This Service Information bulletin supersedes SI 11 04 12 **dated May 2012.**

Voluntary Emissions Recall Campaign 11E-A03: Check and/or Replace Emissions Monitoring Components

E70 and E90 with the M57Y engine produced from January 2010 to March 2011

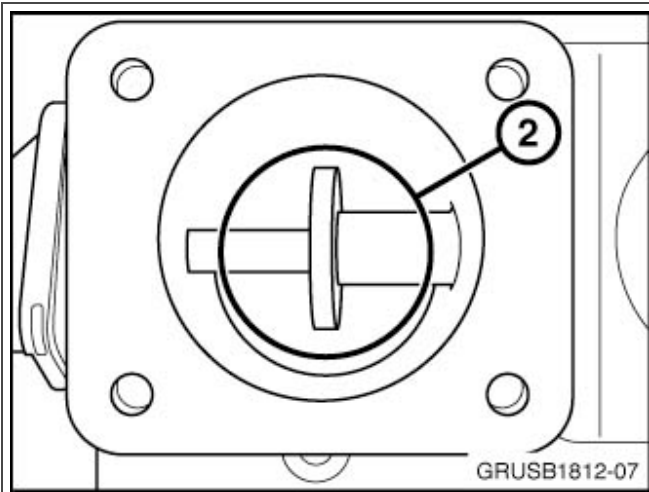
Remove the charge air pipe at the throttle (ignition off). Using a flashlight, look through the throttle (1) and inspect the EGR valve.

The original EGR valve has a diffuser in the airstream flow from the throttle (2). The valve for EGR actuation is seated further into the EGR airstream. Replace this valve with P/N 11 71 8 512 526 (Repair Instruction 11 71 501).

The updated EGR valve (P/N 11 71 8 517 217 or P/N 11 71 8 512 526) has the valve and seat directly in the airstream of the throttle (1). If this valve is installed, no further action is needed. Reinstall the charge air pipe.
